ACCESS REPORT

PROJECT: Ulladulla Public School upgrade
PROJECT NO: GDL240199
PREPARED FOR: Department of Education (DoE)
REVISION: H
DATE: 25.03.2025

This Access Consultant 100% Schematic Access Report has been prepared to support a Review of Environmental Factors (REF) for the NSW Department of Education (DoE) for the Ulladulla Public School upgrade (the activity).

EXTERNAL WORKS SITE PLAN

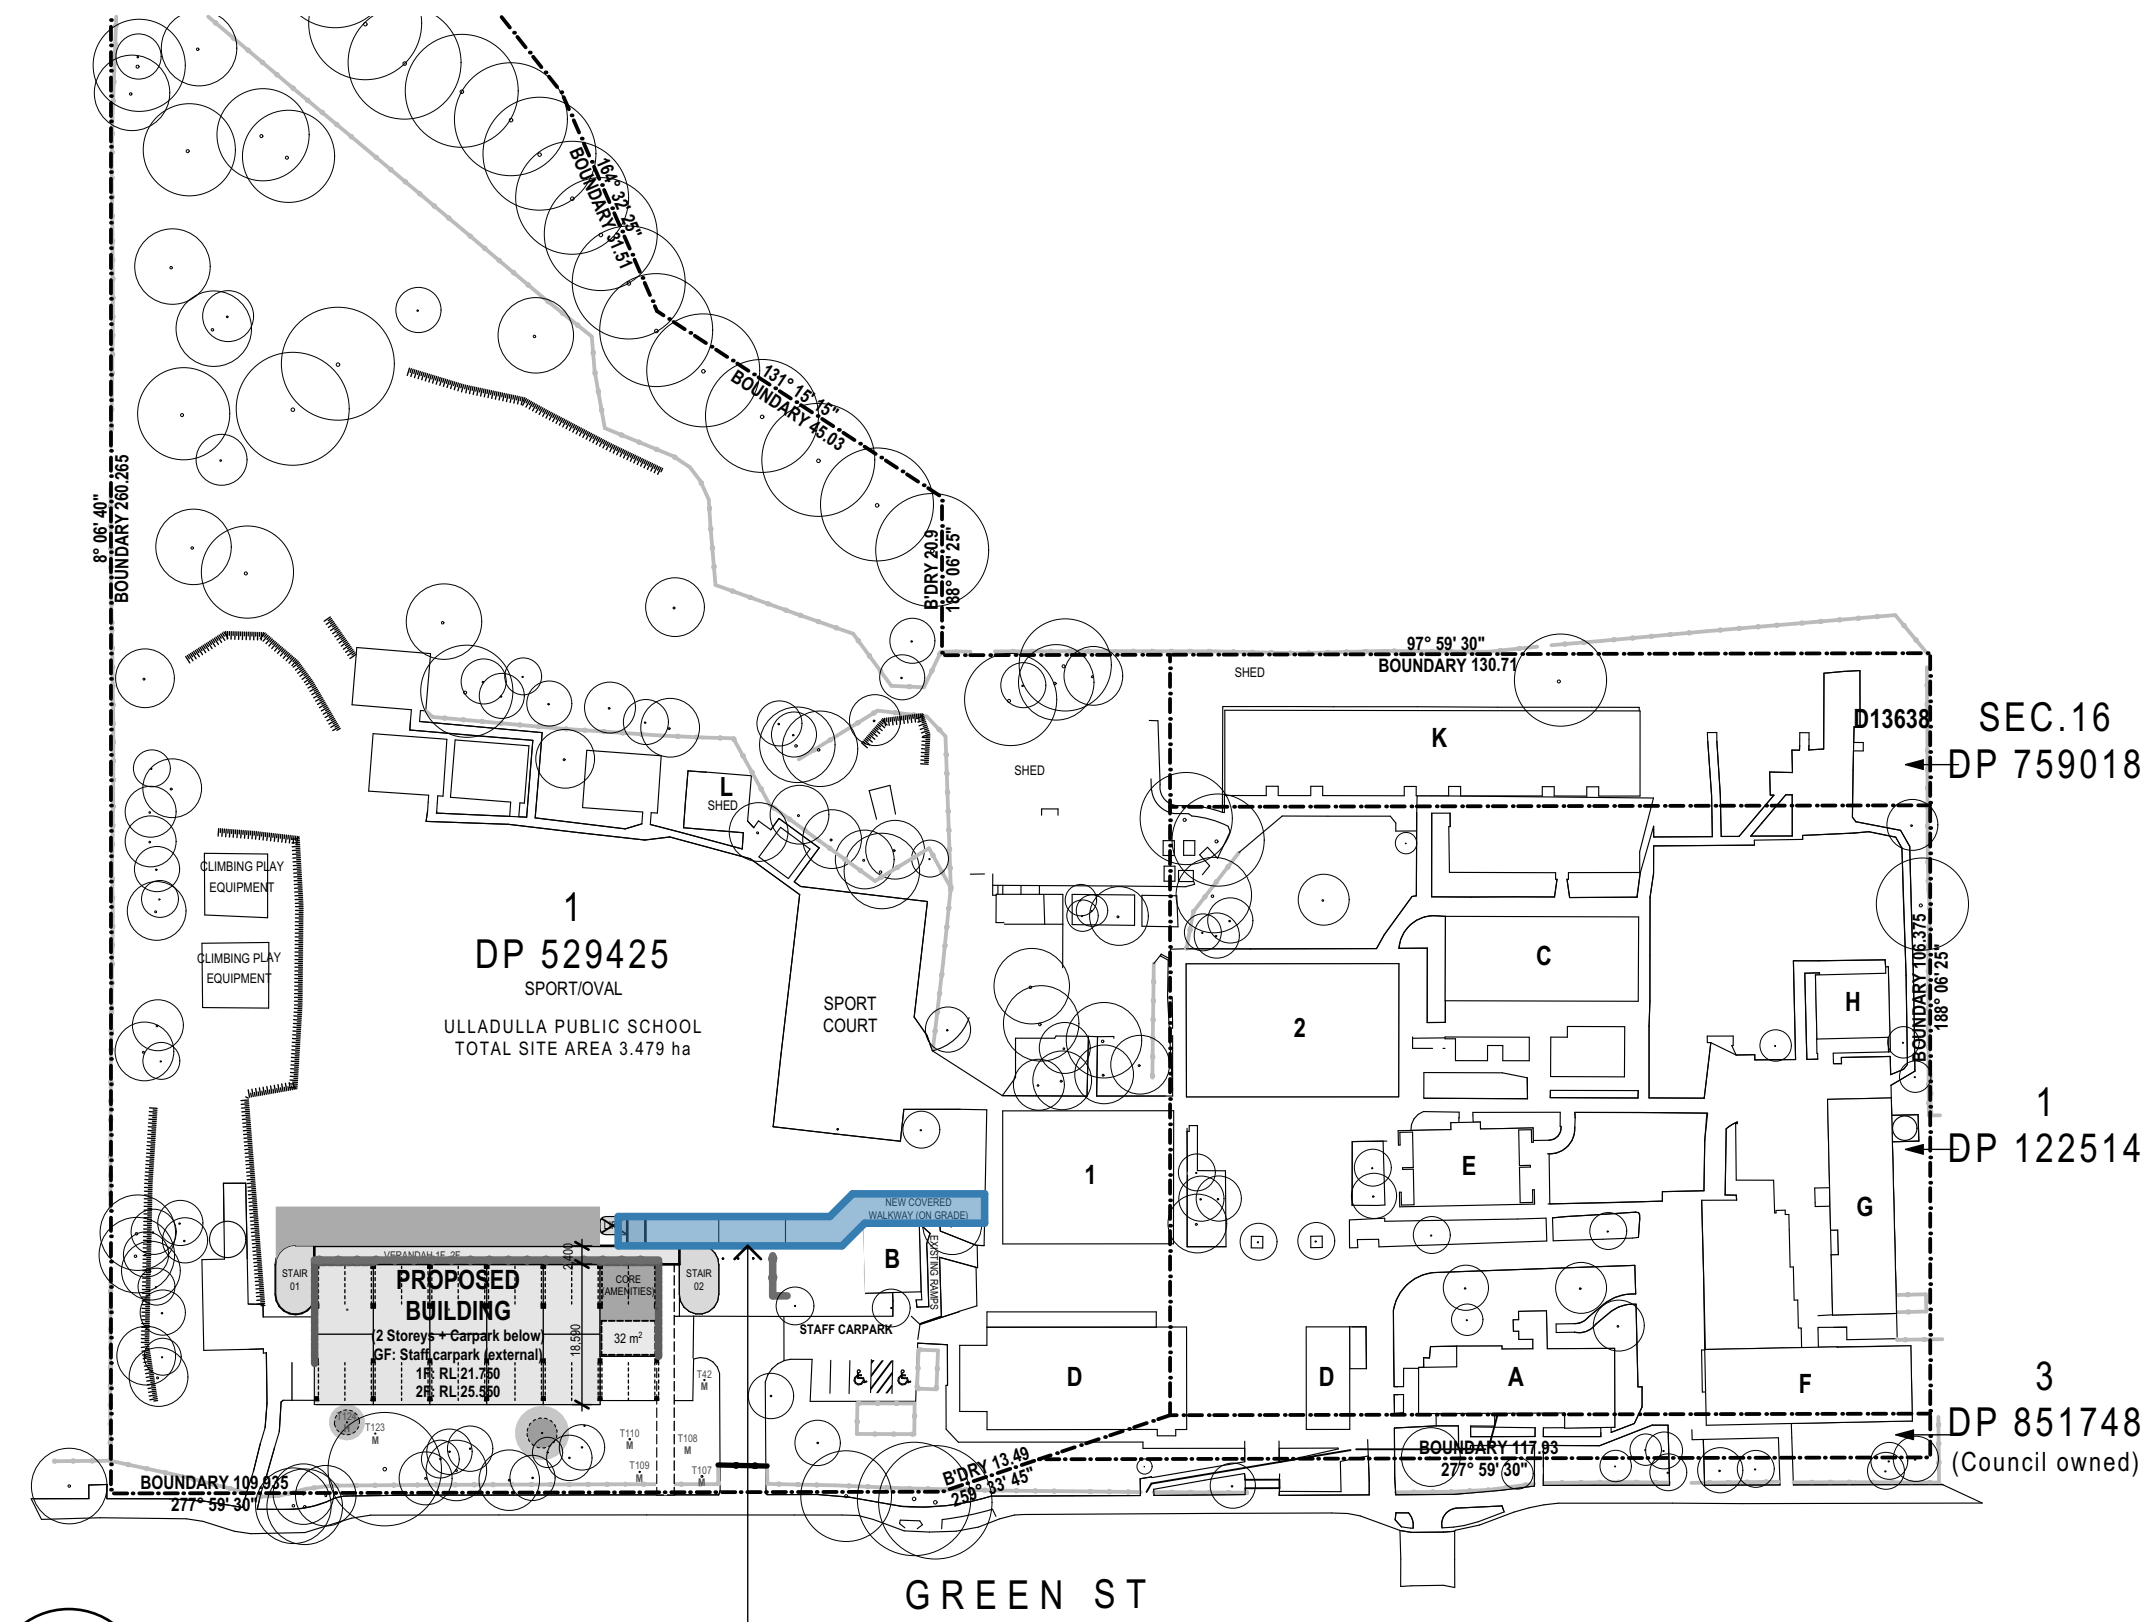
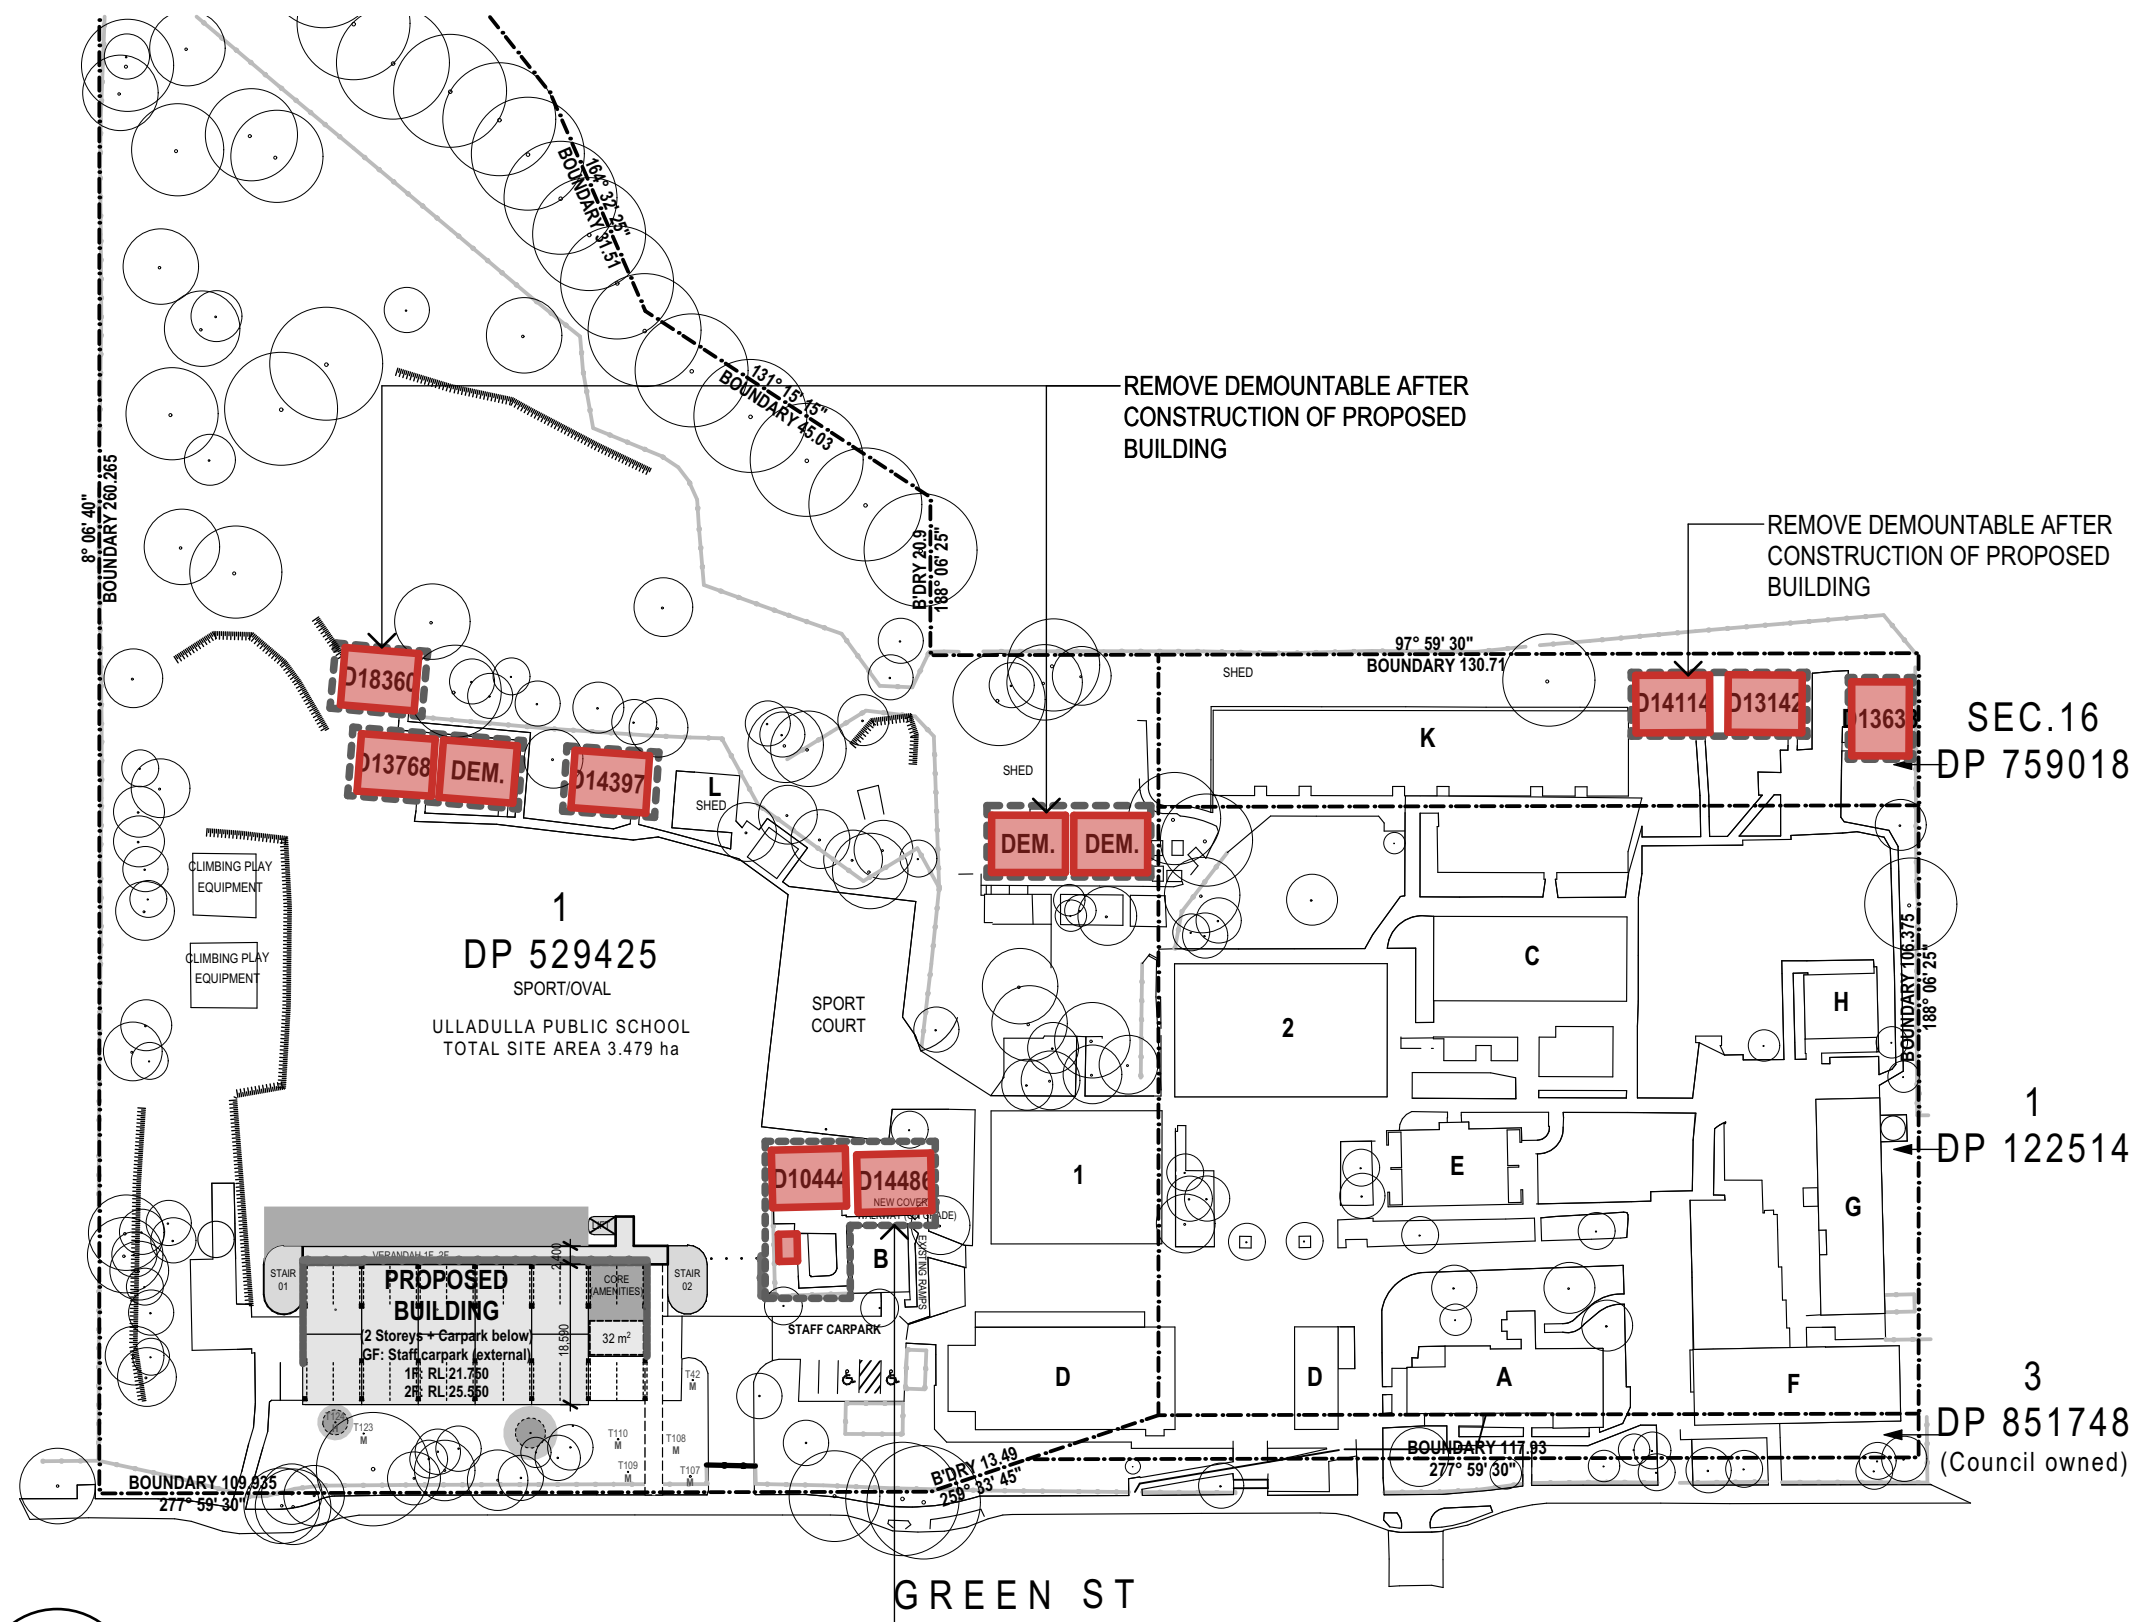
DETAILED SURVEY TO THESE TWO EXISTING
RAMPS TO BE PROVIDED. MAKE ALLOWANCE
FOR MINOR UPGRADES TO EXISTING RAMPS
AND LANDINGS TO MEET COMPLIANCE TO THE
GREATEST EXTENT POSSIBLE (EG. NEW
HANDRAILS, TGS, LOCALISED REGRADING
TO REMOVE TRIP HAZARDS ETC).
